Re: Documents to support CM/29/26/L

1 attachment (3 MB)
Block Plan 2nd Oct.pdf;

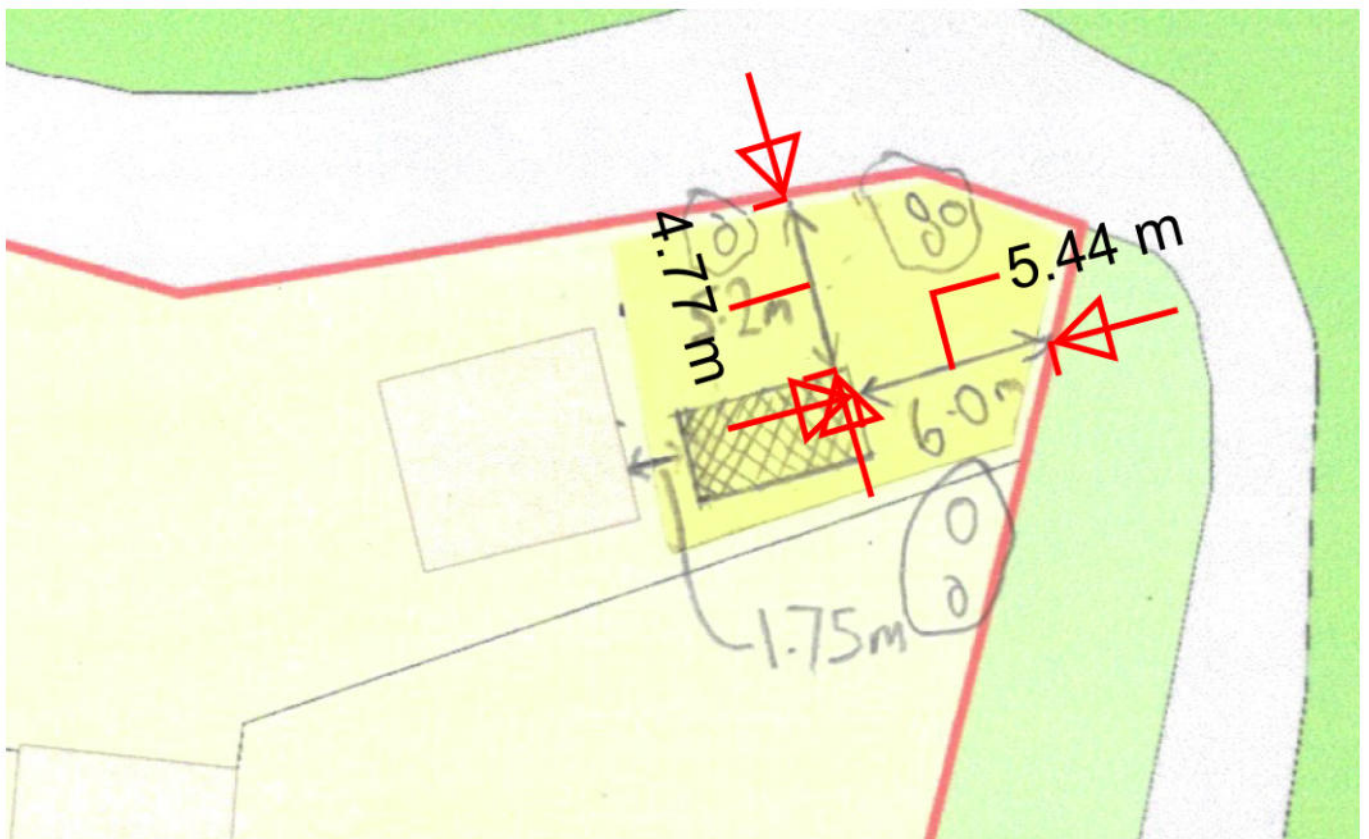
Below is the image of our measuring tool on your plan, I would suggest rubbing out the line that is 1.75m between the proposal and other building as that isn't needed.

Hi Ella,
Amended Block Plan attached.
Kind regards,
Hilary

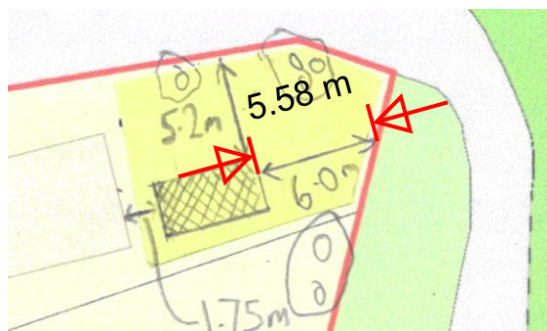
I apologise if there appears to be any miscommunication due to the image I sent you but all dimensions from the proposed works needed to be more consistent, not just the one I used as an example.
